**Air Top 3500/5000 Burner Replacement Kit**

08-10-2000

**Improved Burner Chamber and Burner Tube for the Air Top 3500 / 5000 Heaters**

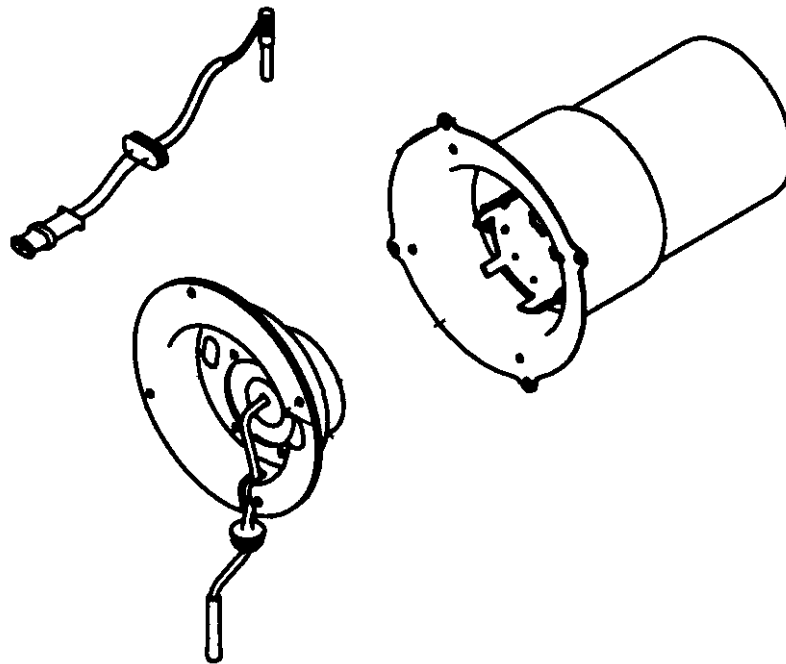
A manufacturing change to the Air Top 3500 and Air Top 5000 burner chamber and burner tube begins 12/99. This enhancement reduces the thermal load on the ceramic igniter effectively increasing the life span of the igniter.

Due to good product reliability to date, it is not necessary to replace burner chambers and burner tubes in units currently in service, however, when heaters are serviced, they can be brought up to the new standard.

To perform this modification, it is necessary to replace the burner chamber and burner tube. For this purpose, we have developed two burner upgrade kits, one for 12 volt units and one for 24 volt units.

Upgrade parts for changing current (former) standard to the latest standard - AT 3500/5000.

12 Volt Upgraded Burner Kit .....	67984A
24 Volt Upgraded Burner Kit .....	67956A
Workshop Repair Manual .....	63380A
